END OF ADDENDUM 1

DAYTON SCHOOL DISTRICT
CAPITAL BOND PROJECT
DAYTON GRADE SCHOOL ATTIC ABATEMENT
FORM OF PROPOSAL
SECTION 00 4100

Dayton Elementary School
Attic Abatement Locations

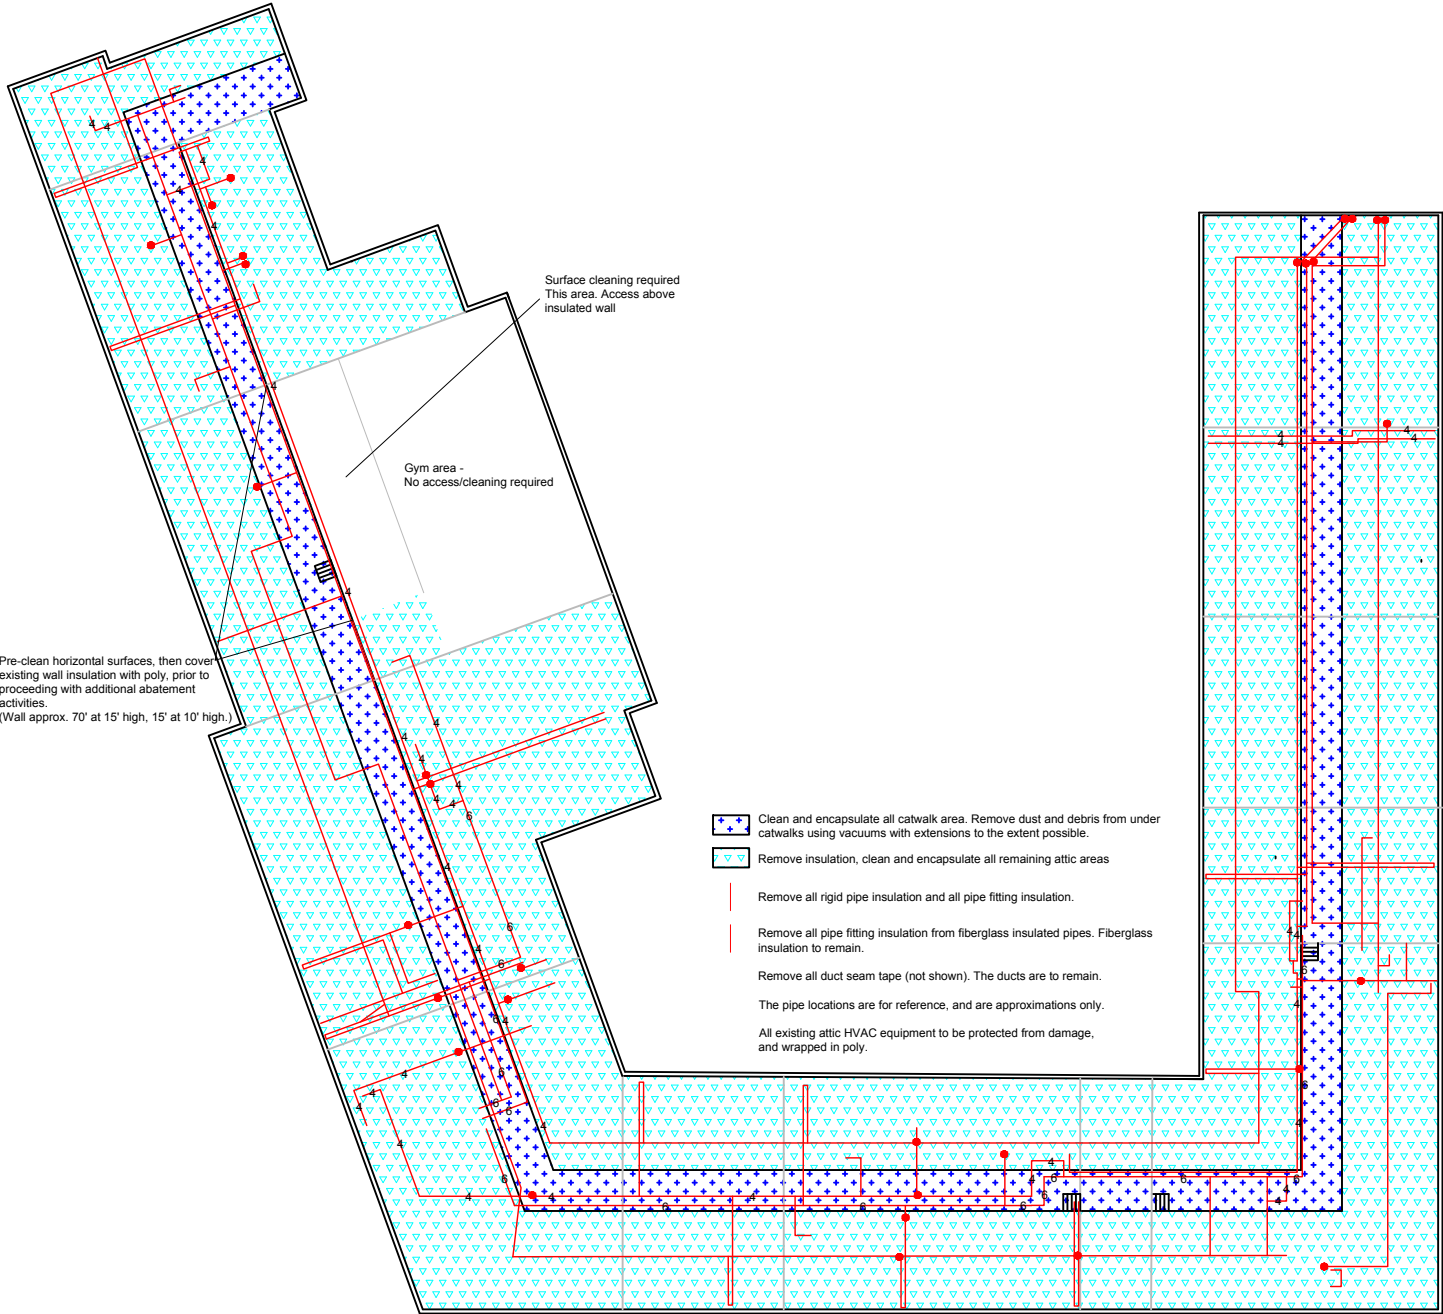
Disregard **original** drawings (APPENDIX A) Asbestos Abatement and replace with **attached** Asbestos Abatement drawings.

Question: Drawing shows removal of insulation from attic in Gym. I thought there was a wall along the attic that separates that and there was no work in that area?

Question: Can we remove part of the ceiling below work area for access and then replace?

Question: What do you expect for prep below attic space?

Question: Dust from surfaces cannot be 100% removed or cleaned due to porous surfaces but can be encapsulated. Are you mainly looking for white or gray debris from pipe or duct insulation?

Answer: Clean all accessible areas from the attic space. You are correct, that part of the gym is inaccessible and doesn't require cleaning.

Answer: As discussed at the walkthrough, they want access panels added. HMK to provide the size and style, and the framing requirements. I think we settled on 6 access panels. Two per section, above and beyond existing access.

Answer: Critical. I don't expect much beyond that, as it's mostly hard lid. If there are areas of spline ceiling tile without drywall or plaster above, poly will likely need to go below to prevent debris from falling through. I'm more concerned about workers falling through. So, work practices above need to prevent that, of course.

Answer: All visible dust and debris is to be removed from all surfaces accessible from the attic area. We expect the contractor to use extensions on vacuum hoses to remove as much of the

insulation under the catwalks as possible. Same with open wall cavities. But all surfaces are to be HEPA vacuumed and then encapsulated.
